RS-15-137

Clinton Power Station, Unit 1  
Facility Operating License No. NPF-62  
NRC Docket No. 50-461

Subject: Report of Full Compliance with March 12, 2012 Commission Order Modifying Licenses with Regard to Reliable Spent Fuel Pool Instrumentation (Order Number EA-12-051)

CPS REVISED SKETCH #2 (two pages)  
Depiction of Pool Sensor Locations and Cable Routing

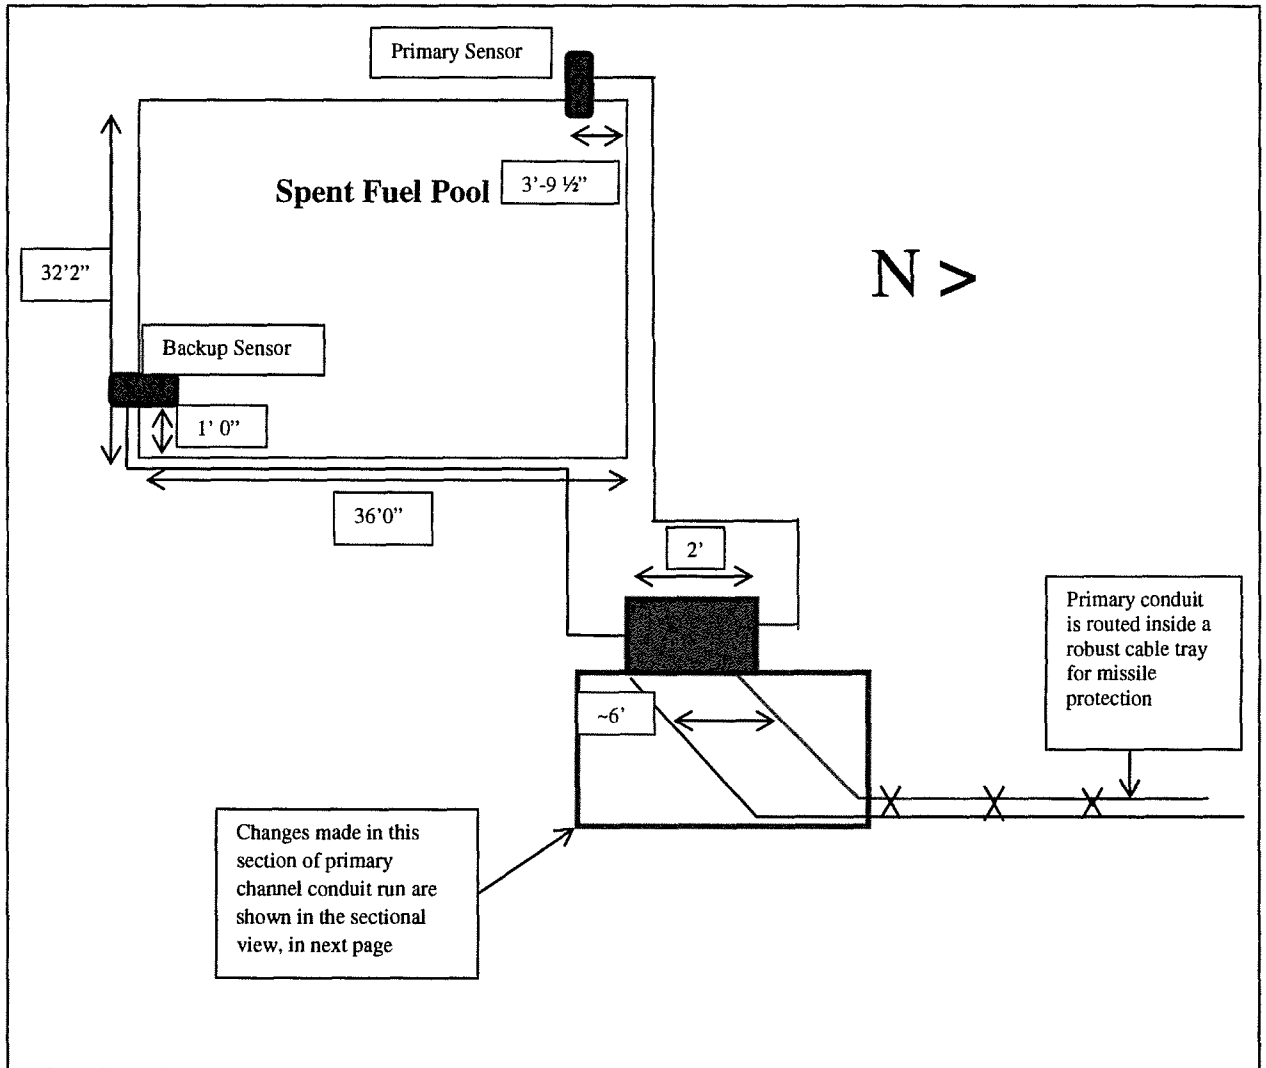
Item	Description	Reference
<b>OIP Item 5 (RAI- 5, Ref. 3)</b> <b>OIP Item 2 (RAI- 2, Ref. 3)</b>  b) Further information on the use of physical and spatial separation	<p>The following is a summary of the additional actions taken to provide as much physical and spatial separation within the Spent Fuel Building area utilizing, to the maximum extent practical, inherent shielding from missiles provided by existing recesses and corners in the Spent Fuel Building structure at Clinton Power Station (CPS) (Reference enclosed Sketch #2).</p> <p>Spent Fuel Probes:            The two spent fuel probes were moved at opposite corners of the Spent Fuel Pool, one on the NE corner and the other on the SE</p>	Complete

<p>corner of the pool, to obtain the maximum extent practical separation. The original design had a separation of approximately 34 feet, and the final installed configuration has a separation of 45 feet, which meets the NEI 12-02 requirement of separating the sensors at least by the shortest distance of the pool edge (i.e., 32 feet).</p> <p>Probe Coax Cable Signal Routing: Where the channels leave the spent fuel area, a change was made so the signal cable is routed in conduit on opposite faces of a two (2) foot wide webbed column, which is part of the support for the Fuel Building, a seismically designed and constructed structure. The channel cables are then routed, after leaving the top of the column, with one conduit (primary) being four (4) feet higher than the other to provide practically achievable separation due to interferences at the top of the column. After approximately eighteen (18) inches, the conduits maintain a separation of six (6) feet for a distance of approximately 10 feet into a separate conduit and a cable tray. At the cable tray, the primary channel is routed in a robust cable tray, and the secondary channel is routed in its own conduit outside the cable tray. The cable tray provides reasonable protection to the primary channel. Both channels are supported by seismically installed support hangers. The cable tray and conduit remain common to the tray supports until approximately ten (10) feet from the North Fuel Building wall, where they then separate, one in the tray and the other in a conduit by a distance of approximately five (5) feet until penetrating the North Fuel Building wall.</p> <p>Structural calculations IP-S-0303 and IP-S-0311 were revised, as required, to address the structural adequacy of conduit supports due to additional separation being provided from the column to the cable tray in the Fuel Building.</p> <p>The above described changes further enhance the design for the SFPI at Clinton Power Station and meet the NEI 12-02 requirements.</p>
